STAFF REPORT

File Numbe	r PL 14-03	PL 14-036		Contact Jen		nn Reed Moses, jmoses@duluthmn.gov	
Application Type	Concurr	ent Use Permit	Planning Commission Date			ate	May 13, 2014
Deadline	Appli	Application Date		April 8, 2014			June 7, 2014
for Action	Date	Date Extension Letter Mailed		April 22, 2014		S	August 6, 2014
Location of Subject 10th Avenue E Between 1st Street and 2nd Street							
Applicant	St. Luke's H	Luke's Hospital		Ron Fra	n Franzen, rfranzen@slhduluth.com		
Agent	Kenneth D.	nneth D. Butler		kbutler@	kbutler@kenbutlerlaw.com, 218-625-2278		
Legal Desc	ription	See attached					
Site Visit Date		N/A	Sign Notice Date		April	April 28, 2014	
Neighbor L	etter Dat	N/A	Number of Letters Sent			N/A

Applicant seeks a concurrent use permit for a new skywalk approximately 15 feet wide by 80 feet long over 10th Avenue E, connecting the existing hospital to the 4th floor of Building A. Skywalk will be approximately 30 feet above the road surface.

St. Luke's Hospital connecting bridge

BRIDGE DETAILS

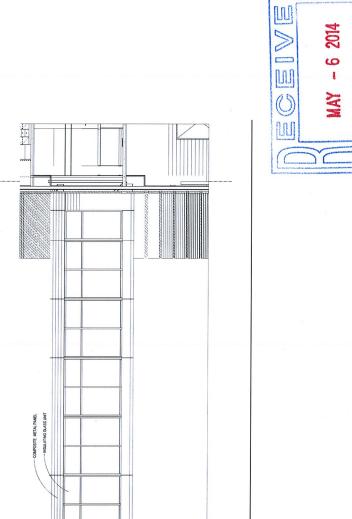
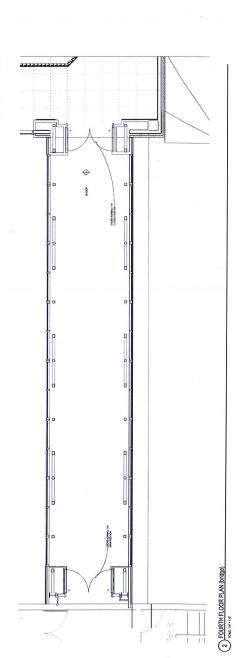
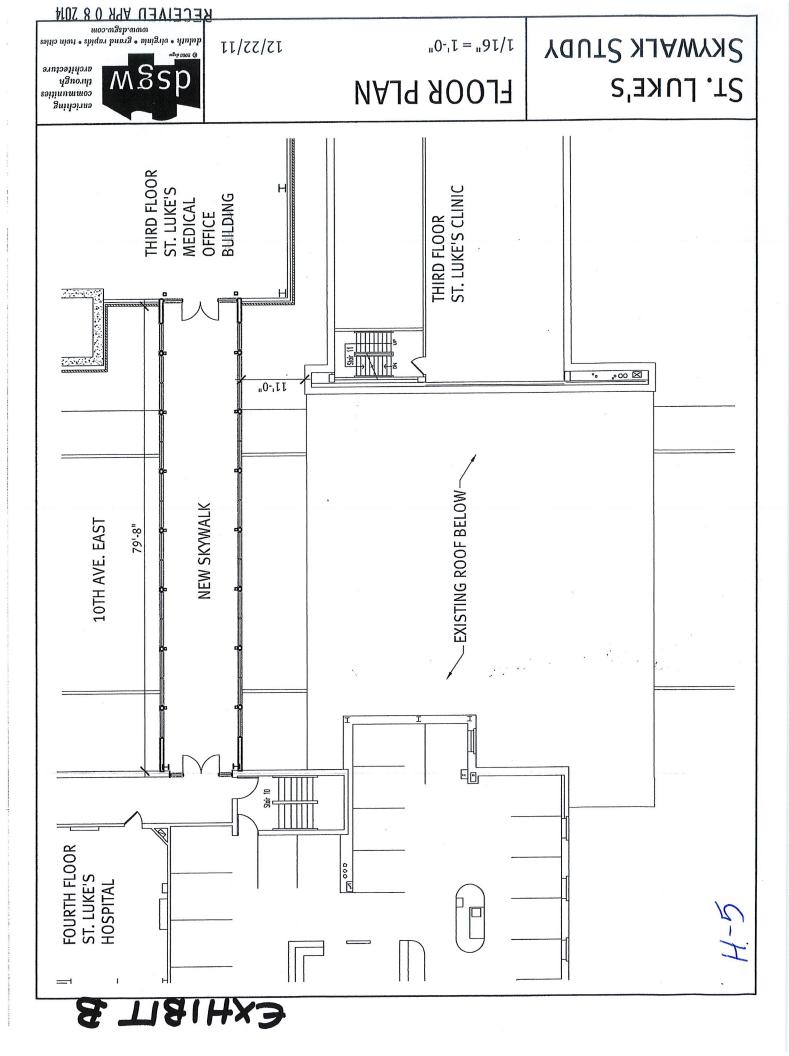
- 1.) The project be limited to, constructed, and maintained according to "Bridge Details," Sheet A138, received May 6, 2014.
- 2.) Applicant provide proof of liability insurance to indemnify the City against any occurrences in the right of way that are due to items covered under this permit.
- 3.) Any alterations to the approved plans that do not alter major elements of the plan may be approved by the Land Use Supervisor without further Planning Commission approval; however, no such administrative approval shall constitute a variance from the provisions of Chapter 50.

As requested in your voice message earlier today, I have attached an updated elevation and floor plan of the bridge. The elevation has been modified in two ways to increase the transparency from 35% to 59%. First, the glass has been extended down to the floor line to increase the area of glass storefront to 692 square feet. Second, the bottom of the bridge has been raised 22 inches to decrease the area of the façade to 1170 square feet. The resulting transparency is just over 59%. An added benefit of this second change is that the clear space under the bridge has increased from 28 feet to nearly 30 feet.

Although we could reach transparency of 67% if the vision glass were to be extended to the extreme ends of the bridge, the glass has been held back for both structural and operational reasons. On the west end of the bridge, at the existing hospital, the doors are in a normally open position to facilitate the travel of surgical patients and staff between the two sides of the surgery department. These open doors and the structural columns behind them would block the view of any glass that might be placed at this location. In addition, the drywall box-outs behind the doors at both ends of the bridge serve to cover the structural connections at the two buildings. Any glass at the ends of the bridge, then, would likely be spandrel glass which, of course, offers no transparency.
